# ADVANCE NOTICE OF REVISION

(This Notice **supplements** all earlier Notices)

**Figure A: Placement of Hat Section Relative to Bellcrank Bracket/Spar Flange Attach Angle**

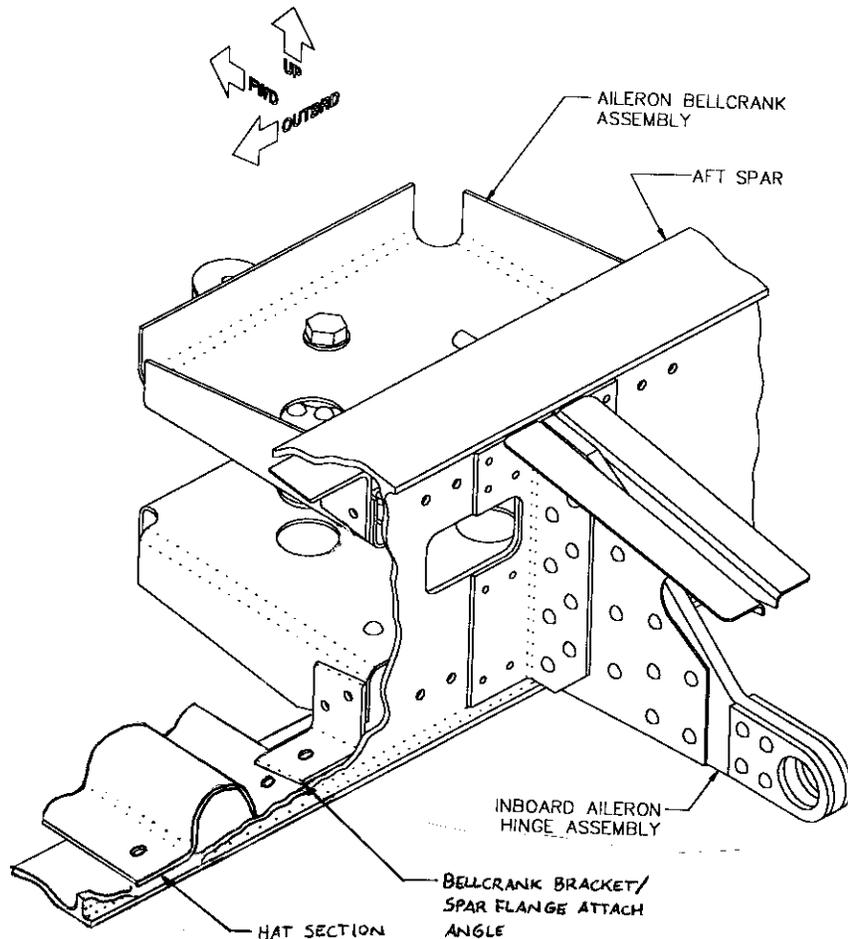
**Page 212:** A Note and illustration will be added to Step 66. The Note will explain and the illustration will show (see Figure A (right)) that the aft inboard corner of the flange of the hat section immediately outboard of the aileron bellcrank assembly must be tucked under the bellcrank bracket/spar flange attach angle. The hat section flanges are thin enough that this slightly unorthodox procedure poses no problem from either a construction or a structural standpoint.

**Figure B: Cutting the Aileron and Flap Cable Clearance Slot**

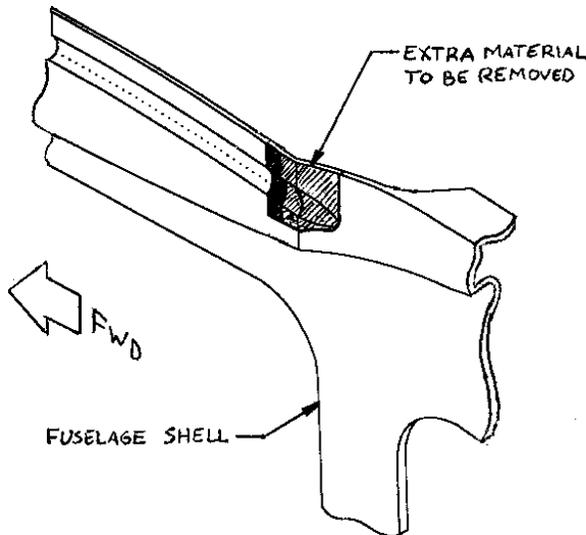
**Pages 28–29:** The text of the second paragraph (including the Note) on Page 28 will be changed to call for cutting away more of the fiberglass fuselage shell than is currently specified. Specifically, the cutout for the **aft** lug of the alignment jig will be extended **aft to the end of the pre-molded depression in the shell** in order to accommodate the flap and aileron control cables. (Even more of the shell will be relieved later when the top-deck hatches are fitted.) Figure B (left) is a thumbnail view of the change that will be made to manual Figure 13 on Page 29.

**Figure C: Bulkhead D Edge Band**

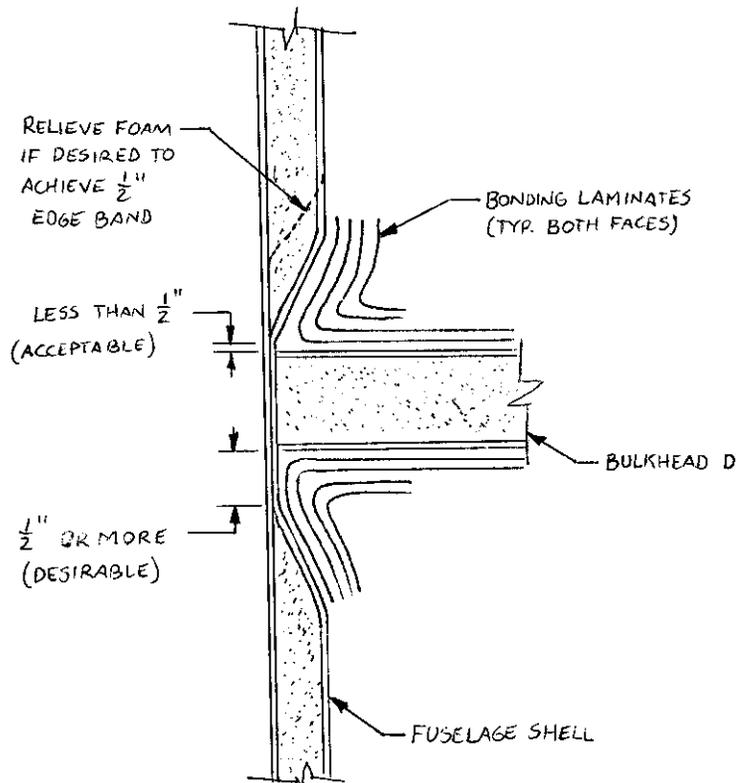
**Page 124:** A Note will be added to Step 68 discussing the positioning of Bulkhead D relative to the foam cutout in the fuselage shells. We have progressively refined the size and location of this cutout to better coincide with the placement of Bulkhead D. However, we are still receiving reports that the bulkhead, when positioned as instructed in Step 68 and Figure 87, rides up on the foam core portion of one or both fuselage shells. Ideally, the laminates used to bond Bulkhead D in place should have a so-called "edge band" of at least **1/2"**, as shown in Figure C (next page). If necessary, and if the builder so desires, he or she can relieve the foam core on one or both sides of the bulkhead to achieve this edge band. However, **this is not strictly necessary. In no event should the position of Bulkhead D be altered in order to achieve better alignment with the existing foam cutout.**

**Figure D: Additional Bolt Clearance Holes Required in Left-Hand Forward Control Cable Cover Half**

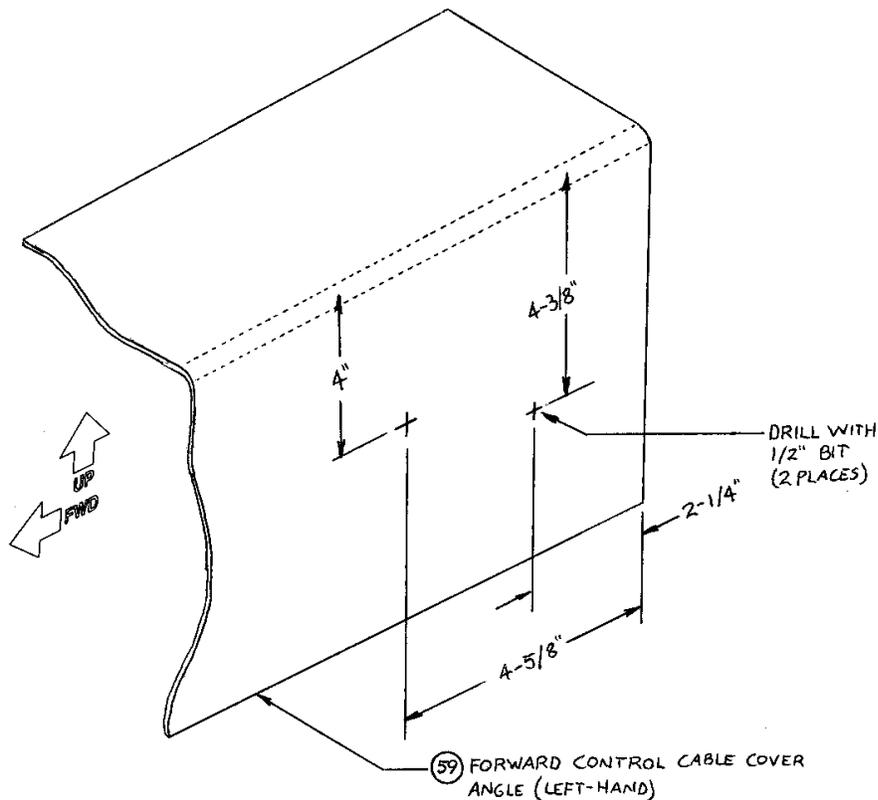
Additionally, text will be added to Step 15 and Figure 14 will be revised to show that two additional holes need to be drilled in the **left-hand** forward control cable cover half to accommodate bolt heads from two pulley groups inside the central truss. These bolt heads protrude left beyond the edge of the truss. Figure D (left) gives **approximate** dimensions for these holes. Double-check these locations before drilling 1/2" holes for these bolt heads.
